FORT JAMES – CAMAS L.L.C.
Proposed N.P.D.E.S. Permit Renewal
Response to Comments

National Pollutant Discharge Elimination System (NPDES) Permits

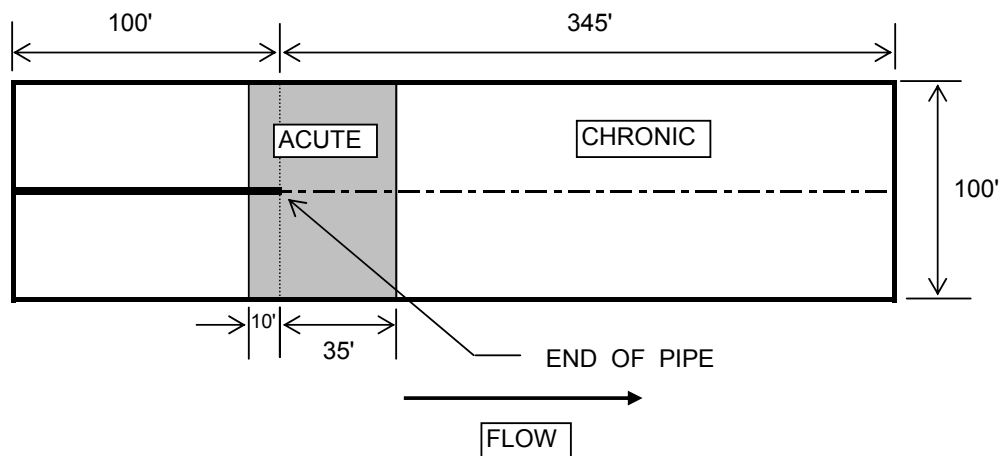
A.1.13 - WAC 173-201A-100(8) requires that: "Acute criteria are based on numeric criteria and toxicity tests approved by the department ... and shall be met as near to the point of discharge as practicably attainable." Has DOE determined at what point acute criteria can be met? What calculations were used to calculate this distance? When were these calculations made? If not, on what ground could DOE conclude that WAC 173-201A-100(8)'s requirements have been met?

See our response to **A.1.3**, on page 4. Most of the time, the length of the zone in which the discharge meets acute numeric criteria (protective of aquatic life) would be less than 45 feet. Under specified circumstances, the permitted mixing zone could allow an exceedance of the acute numeric criteria, thirty-five feet downstream of the discharge point for a seven-day period, occurring on average once in every 10 years (7Q10, the worst case, critical low flow).

The toxicity of a pollutant depends upon the characteristic of the pollutant, the concentration of the pollutant, and the length of exposure to the pollutant. When EPA derived the numeric criteria, they used the data from four-day tests of a pollutant on several aquatic species. They extrapolated the data to derive a no-effect concentration to 95% of all aquatic species if the length of exposure is less than one hour. Therefore, even though the effluent may exceed numeric criteria for a short distance within the acute mixing zone, the probability of mortality for any organism floating or swimming through the effluent, is very small. This probability was determined by hydraulic dilution modeling (using an EPA-approved computer model).
